# Memorandum

<b>To:</b>	Karl Anderson   Senior Planner (Auckland Council)
<b>From:</b>	Matt Ford   Senior Development Planner (Auckland Transport)
<b>Date:</b>	20/01/2026
<b>Subject:</b>	BUN60440759 - 362 Jones Road, Hunua
<b>AUP Information</b> :	The proposed development is subject to the following AUP matters:  <b>Zone</b> Rural – Rural Production Zone
<b>Proposal:</b>	<p>The proposed development includes:</p> <ul style="list-style-type: none"><li>• Establishing a clean fill site operating for 10 years;</li><li>• Up to 790,000m<sup>3</sup> of fill volume is to be imported to the site</li><li>• Operation will be Monday to Friday 7am to 6pm, Saturday 7am to 1pm, and no operations on Sunday or public holidays;</li><li>• A new vehicle entrance established to Hunua Road;</li><li>• Localised shoulder widening at site entrance;</li><li>• Proposed road widening of Hunua Road and centreline adjustments;</li><li>• Vegetation removal and trimming;</li><li>• Average of 52 truck movements a day (26 movements in each direction).</li></ul> <p>Overall, the proposal required consideration as a <b>Discretionary</b> activity.</p>

Figure 2 vegetation to be removed at site entrance

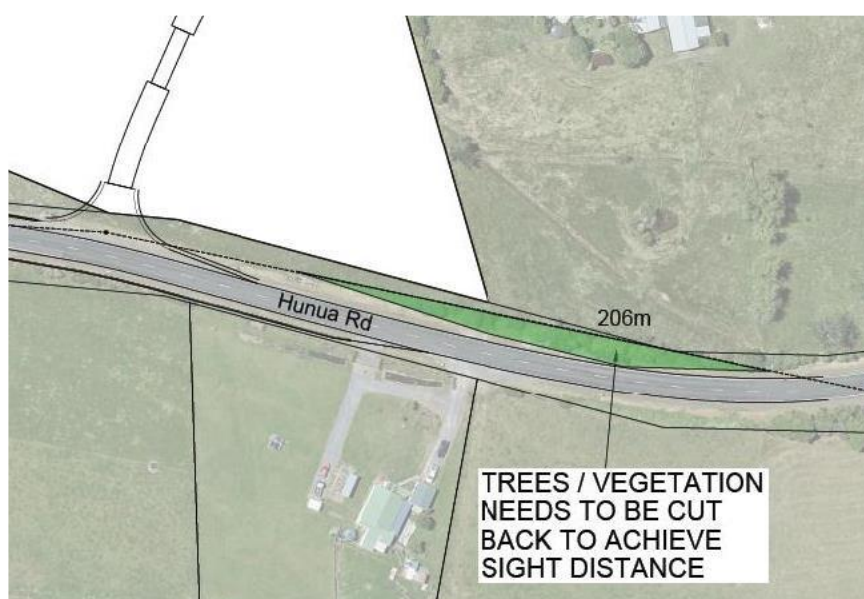
44. Hunua Road has a posted speed limit of 80 km/h adjacent to the subject site access. Therefore, according to AustRoads, the required sightline distances are 182m to the west and 207m to the east. At the site access, the available Safe Intersection Sight Distance (SISD) to the west is currently 198m, which meets the required 182m sight distance. The available sight distance to the east is currently 180m and therefore falls 27m short of the 207m requirement.

45. The eastern sightlines are restricted by vegetation located within the road reserve. The Applicant has recommended they be responsible to trim this vegetation to improve the visibility from the site access. Upon trimming of the vegetation, the achieved sight distance of will be 206m where 207m is required. In a scenario where the consent is approved, AT could accept the achievable sightline distances. This is because AT can accept a  $\pm 2\text{m}$  shortfall considering the fluctuating operating speeds of 75–78 km/h, indicating a practical compliance.

46. If the consent is to be approved, AT recommends consent conditions requiring this vegetation to be removed in full rather than periodically trimmed, to maintain safe sightlines and reduce long term costs. The Applicant would need to remove this prior to the commencement of the activity.

Figure 3 sections of vegetation removal needed on Hunua Road

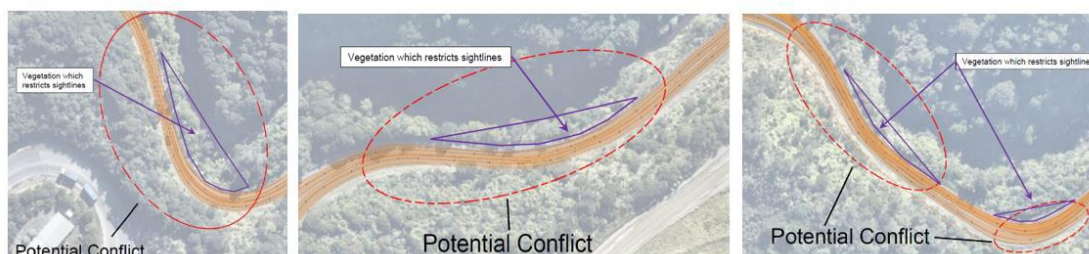
47. The Applicant undertook a wider assessment sightline assessment along Hunua Road. On the constrained sections of Hunua Road (Sections A - D), it was determined by the Applicant after investigation, that sightlines were partially blocked by vegetation along the road reserve. The Applicant has stated that they will take responsibility for improving the sightlines in Sections A–D by regularly trimming / maintaining the vegetation for the life of the consent.

48. While the Applicant has not clearly defined what the existing sightline distances are and what can be achieved post vegetation trimming, it is understood that this would be a net positive outcome. The extent of vegetation maintenance can be seen in Figure 3.

49. Vegetation trimming was considered best practicable rather than full removal because full removal could likely result in ground instability of the gorge and potentially resulting in land sliding into the stream. AT agreed with this assessment presented by the Applicant’s specialists. If the consent was sought to be approved, AT recommends consent conditions are provided by the Applicant to confirm the measured values, demonstrate that it meets AustRoads SSD/SISD requirements at the relevant sections, and adopt a maintenance approach that avoids slope instability would be required.

50. AT notes that while vegetation maintenance can be managed at a margin and is an attempt to mitigate adverse safety effects, it does not address the principal safety constraint of Hunua Road Sections A–D not being able to accommodate simultaneous truck and trailer movements as detailed in section 6.1 above.

Figure 4 crash data locations

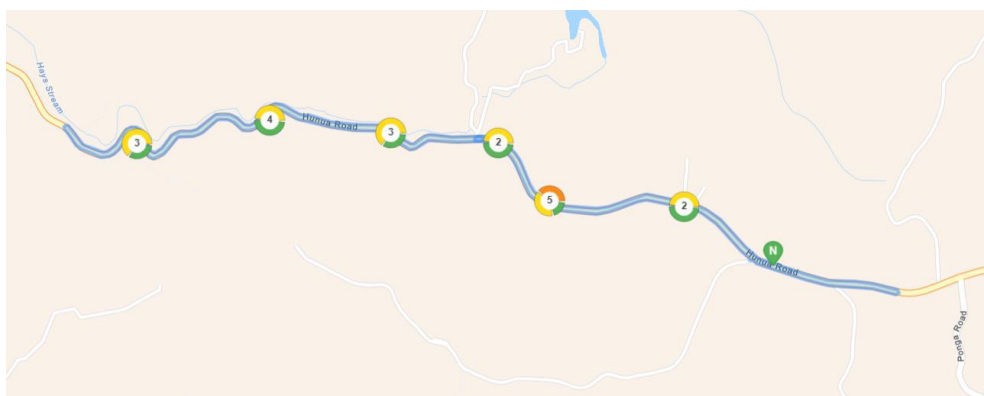
53. The Applicant provided crash data for the five-year period 2020 - 2024 including all available records for 2025, for Hunua Road between Dominion Road and Ponga Road. As such, the search area covers 6.5km of rural road. Crash reports contained in CAS are provided by police. It should be noted that not all crashes which occur are reported to police, particularly less serious crashes, and it is likely that there are some crashes which have occurred in this part of Hunua Road which are not included in CAS. Figure 4 below shows the approximate location of the crashes on Hunua Road.

54. The recorded crash history for Hunua Road shows a total of 39 reported crashes, comprising 20 non-injury, 14 minor-injury, and five serious-injury incidents. The majority of these (26 crashes) were loss-of-control events, often involving vehicles departing their lane and striking roadside objects. A smaller number (four crashes) were head-on collisions, generally associated with a vehicle crossing the centre line following a loss of control. The PTM memorandum notes that increases in traffic volumes (particularly involving heavy vehicles) can heighten both the likelihood and the severity of such

55. Crash records involving trucks include five incidents, two of which were serious-injury head-on collisions west of the Winstone Quarry entrance, both caused by cars crossing the centre line. Although this pattern is considered not directly attributable to the proposal given existing truck volumes in that section between the quarry entrance and the site entrance (being the section most relevant to the proposal), there remains a persistent loss-of-control crash pattern, and heavy vehicles are not insignificant contributors to overall network risk.

*Photo 2 Road safety barrier next to gorge on Hunua Road. Corresponding Commute tracking drawing number 4C.*

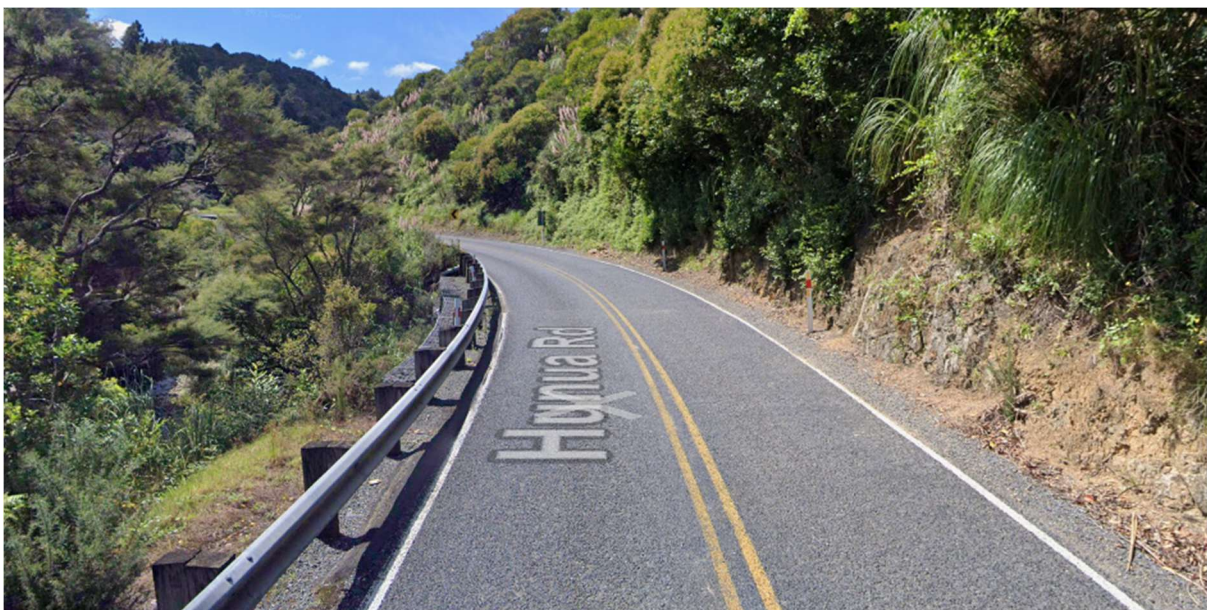
15. There are variety of types of road safety barrier in this section of Hunua Road. AT's engineering standards require that new road safety barriers in Auckland need to be of a type approved by NZTA. Approved types are listed in the appendices to NZTA's M23 Road safety barrier systems specification. Barrier systems are rated by their test level, which is the level of containment they are designed and tested to provide for different vehicle types, impact speeds, and angles.

19. Photos 1, 2, 3, and 4 below show the road safety barriers along with the corresponding vehicle tracking drawings prepared by Commute.

Figure 2: Locations where vegetation will be trimmed and maintained to maintain inter-visibility between drivers travelling in opposite directions.

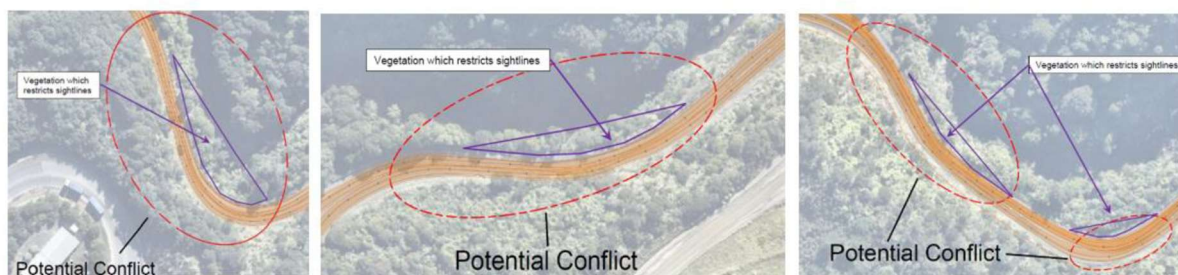
23. This requires the driver of the other vehicle to see the approaching truck and trailer before the vehicles meet. In order to ensure that there is sufficient inter-visibility between drivers travelling in opposite directions the applicant is proposing to trim vegetation on the inside of four curves on the gorge side of Hunua Road. The locations of the vegetation to be trimmed are shown in Figure 2 below.

24. Ongoing maintenance of the vegetation will be required to ensure that it does not grow back to interfere with visibility and my understanding is that the applicant is willing to agree to a condition to do this every six months.

25. While this vegetation removal allows drivers approaching a truck and trailer which has crossed the centre line near a curve sufficient time to take evasive action before a collision occurs this relies on the driver to pay sufficient attention to notice that they need to take this action. While most drivers will be focused on the driving task and will do this, not all will and a proportion of drivers will not take action to position their vehicles towards the left edge of their lane to provide space for the approaching truck to pass. There is still a potential risk of a head-on crash.
